Land at North Colwell Farm: Planning Application Highways Second Response

Ref: MG/BC/ITL19597-009A TN
Date: 2 June 2025

DRAWN:	CHECKED:	APPROVED:
SH	BC	VP
PROJECT No:	SCALE @ A2:	DATE:
ITL19597	1:500	24.01.24
DRAWING No:	ITL19597-GA-004	
REV:	H

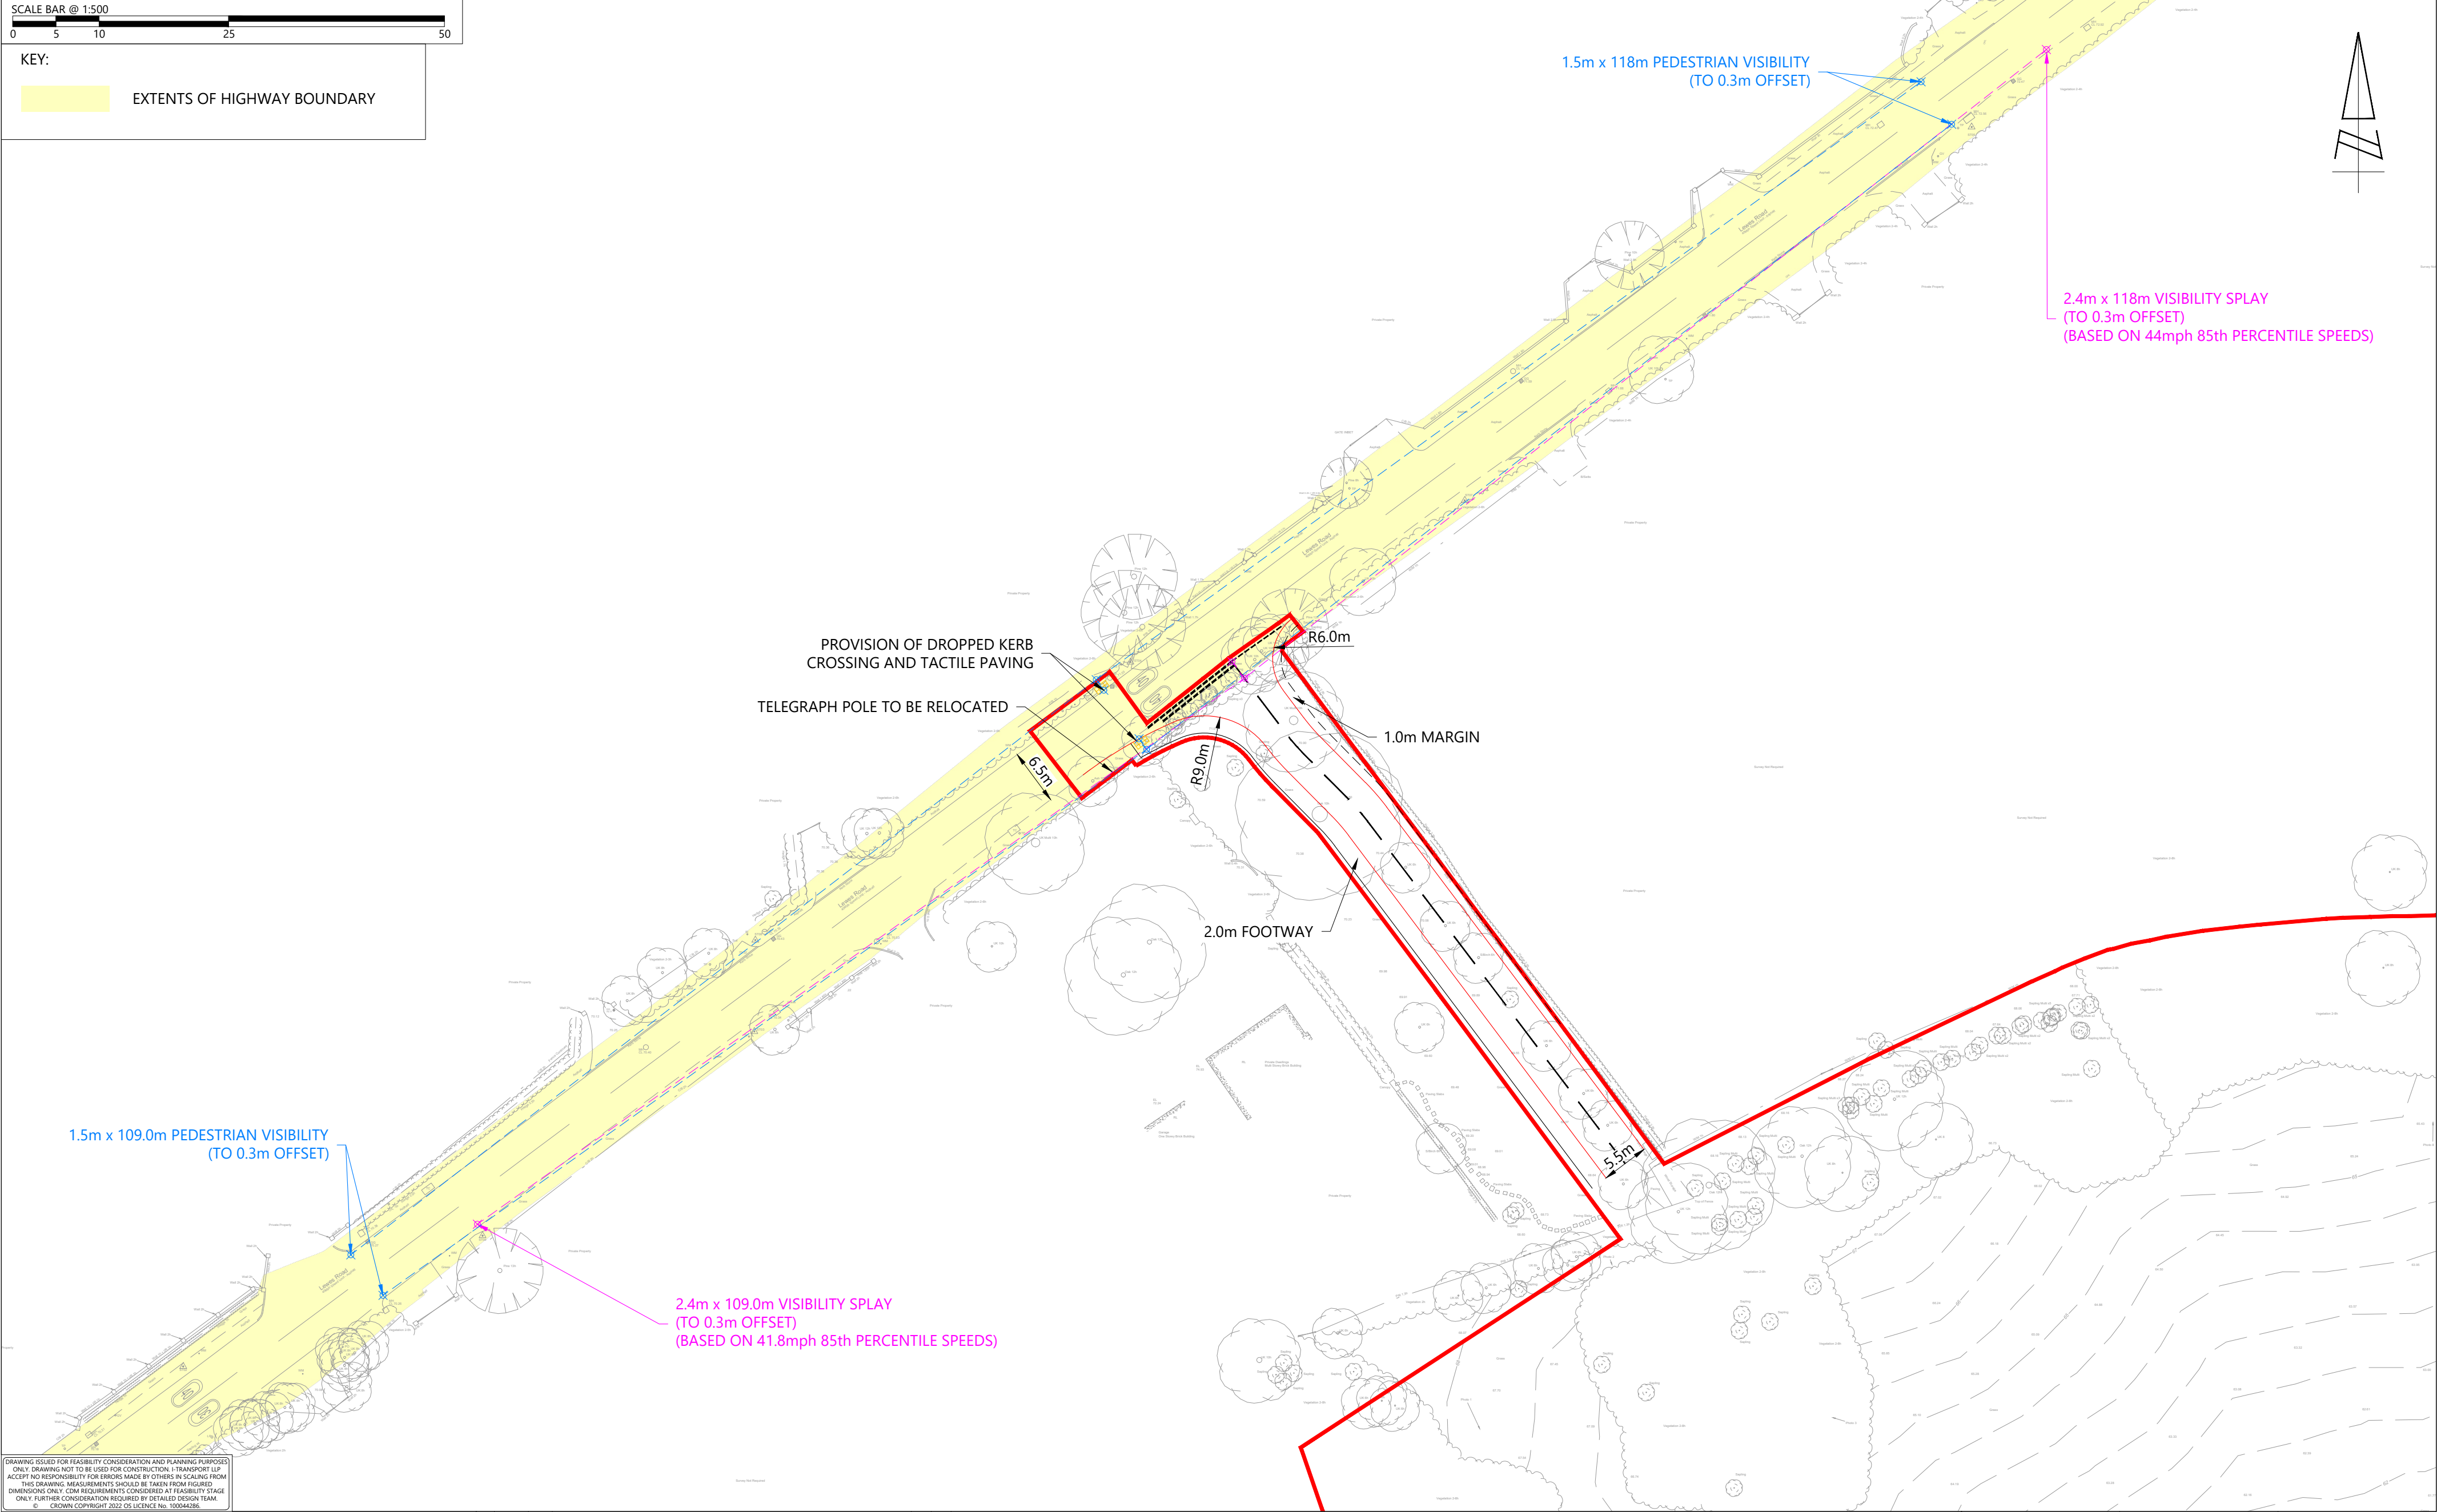
- 4.1 We note a request in the WSCC consultation response to local resident that asks the developer to confirm they are able to amend their junction design to incorporate the visibility splays from alternative traffic data.

- 4.3 It is noted that a total distance of 118m is shown to the north east for the westbound approaching traffic and 109m for the eastbound approaching traffic, these figures were swapped around in WSCC table response to local resident.

- 4.2 The traffic data was held by WSCC and dates back further than the surveys undertaken as part of the application (from November 2022). However, the proposed site access visibility splays have been revised for robustness, these are shown on drawing **ITL19597-GA-004H**. It can be seen that the revised visibility splays requested (1m additional distance south west and 6m additional distance north east) remains achievable in the adopted highway/red line extent.

DRAWN:	CHECKED:	APPROVED:
TA	BC	MG
PROJECT No:	SCALE @ A3:	DATE:
ITL19597	1:500	27.05.25
DRAWING No:	ITL19597-GA-021	
REV:	A

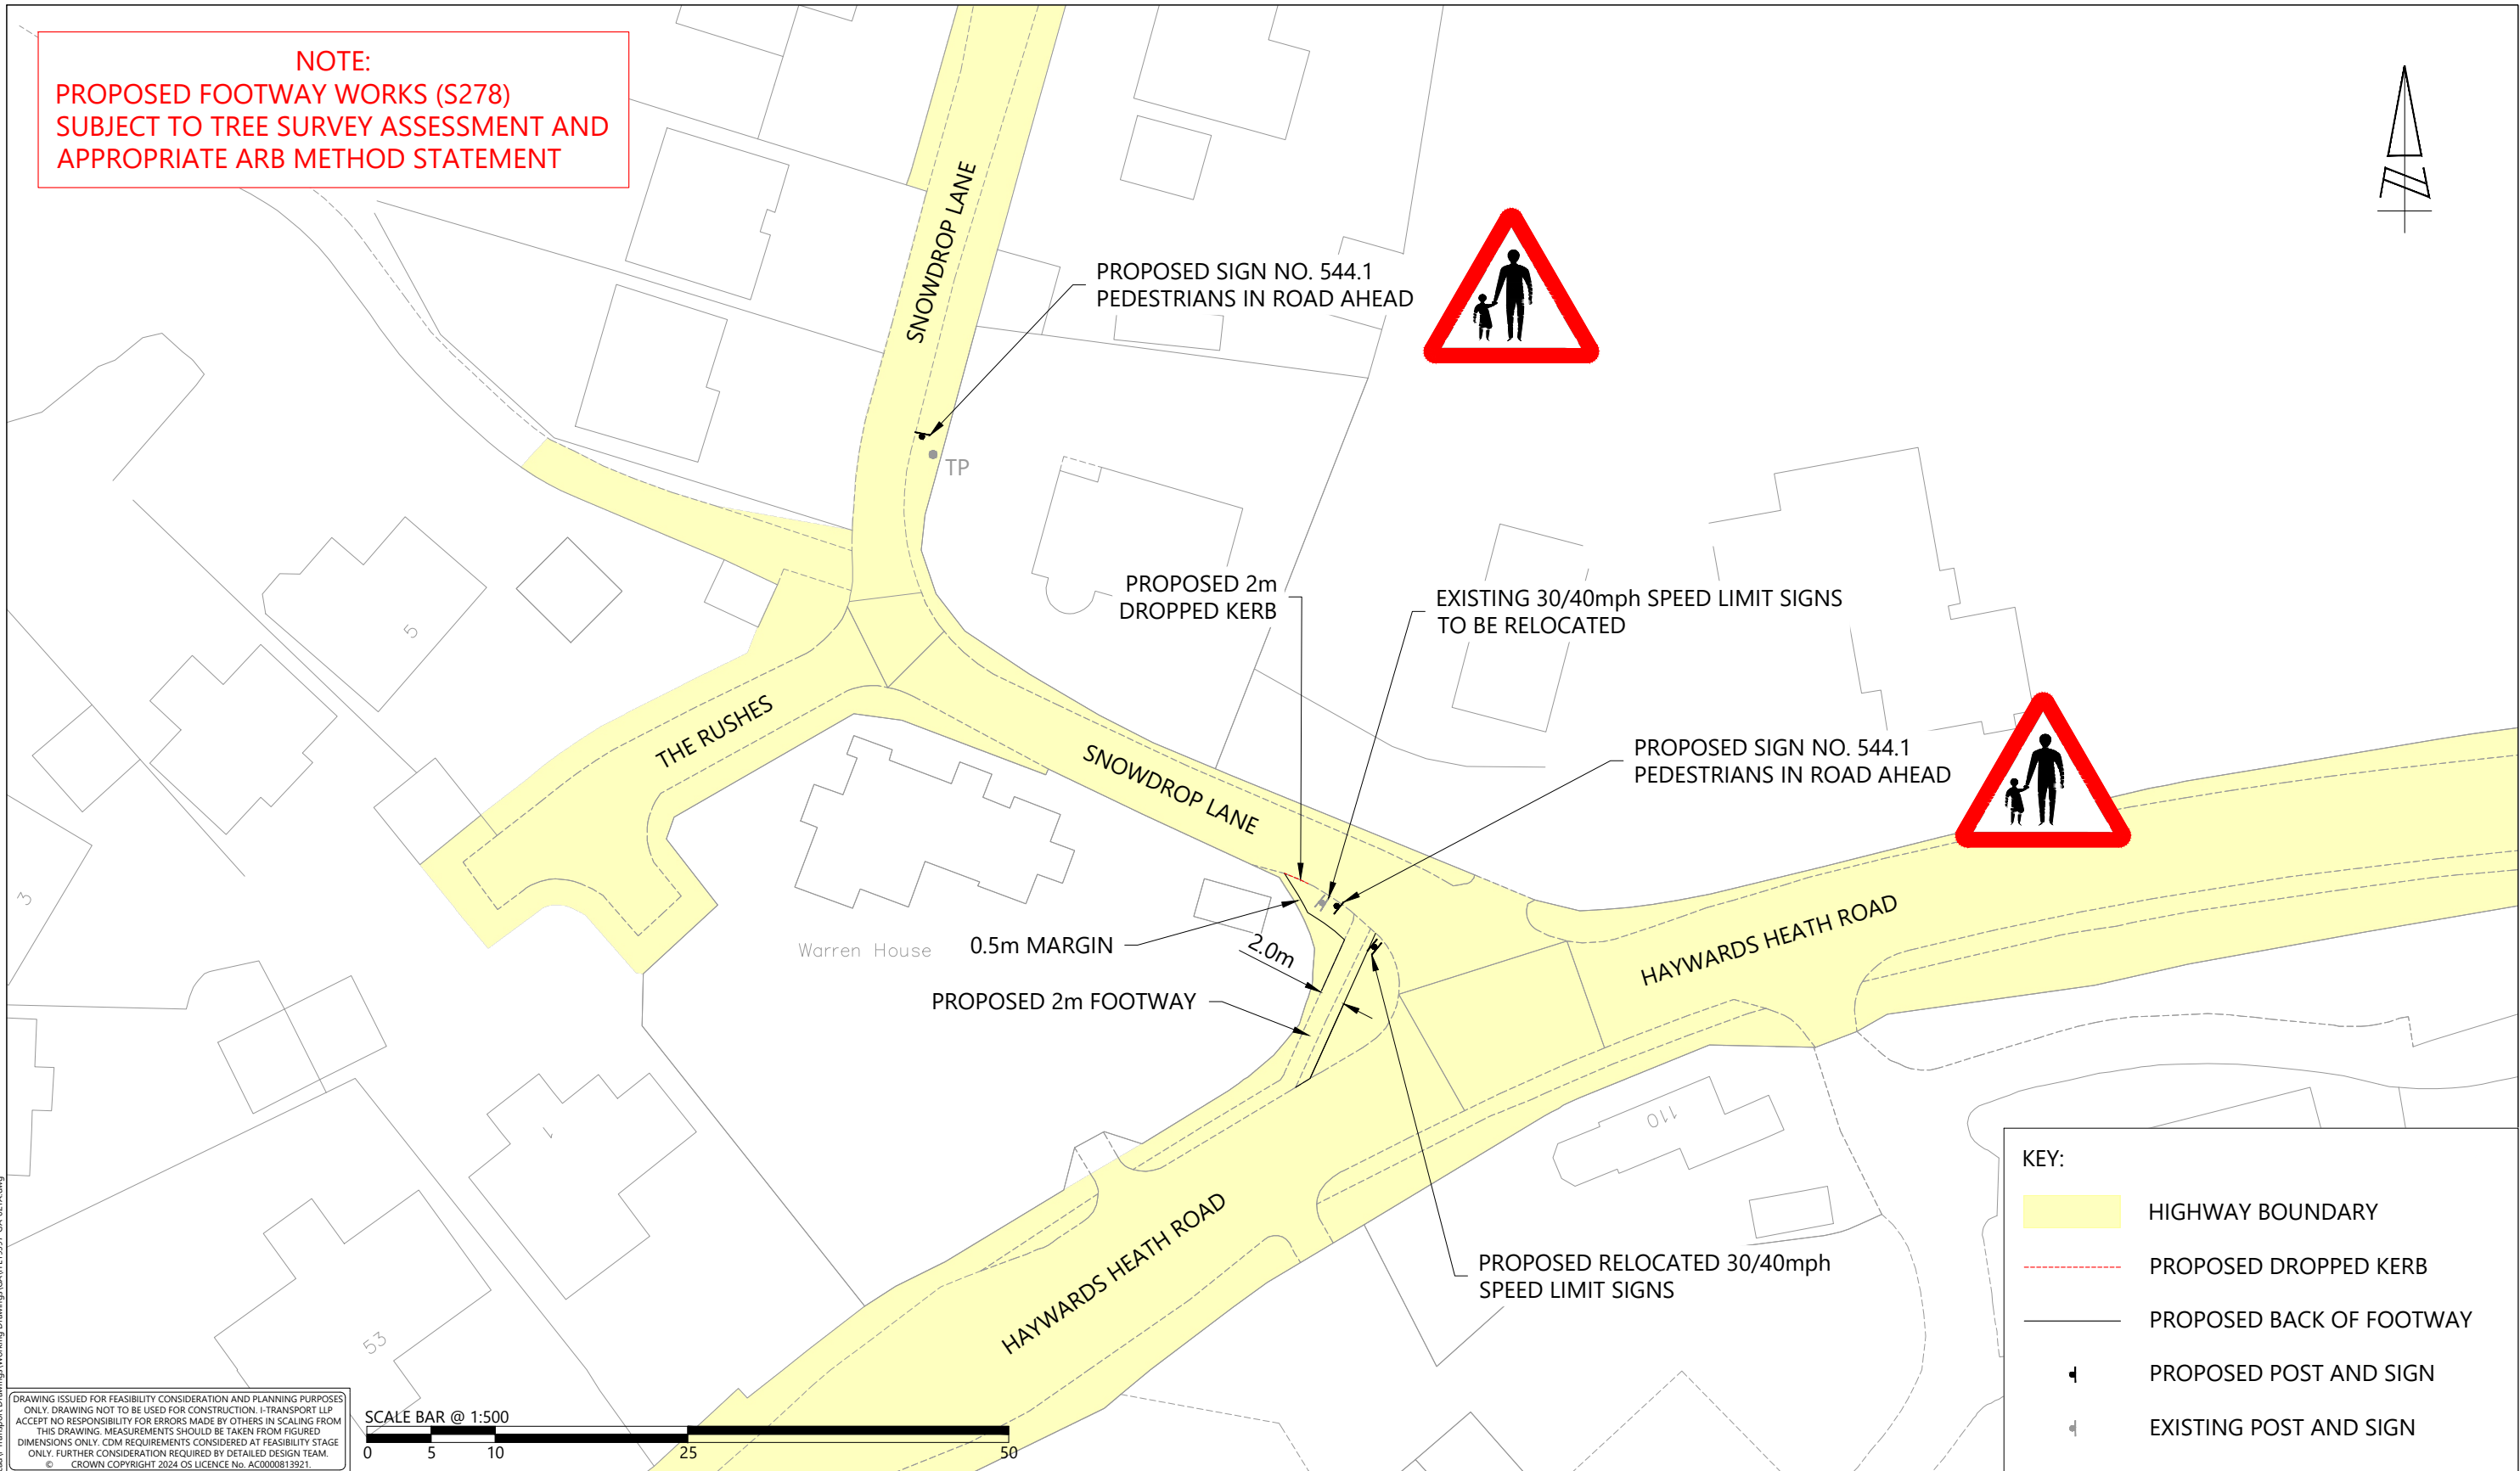
- 2.2 WSCC highways consultation response notes whether there is any mitigation the developer could provide along Snowdrop Lane to alert drivers to pedestrians walking in the road.

- 2.3 Snowdrop Lane is a shared surface road (with 30mph speed limit), where pedestrians and vehicles share the same space without physical separation or markings, encouraging all road users to share the space equally. WSCC highways note which we agree, there is limited space to provide a separate kerbed footway along Snowdrop Lane between Haywards Heath Road and Marlow Drive (distance of c50m).

- 2.5 Therefore, and following discussion with WSCC highways the following is proposed:
- Provide an extended area of footway/hardstanding with drop kerb along Snowdrop Lane at the junction with Haywards Heath Road.

- The above requires the relocation of the existing 30mph speed limit sign by circa 5m.
 - The addition of two new traffic signs to note 'Pedestrians in Road Ahead' via TSRGD¹ Diagram 544.1.

- 2.6 The above has been illustrated on drawing **ITL19597-GA-021**.
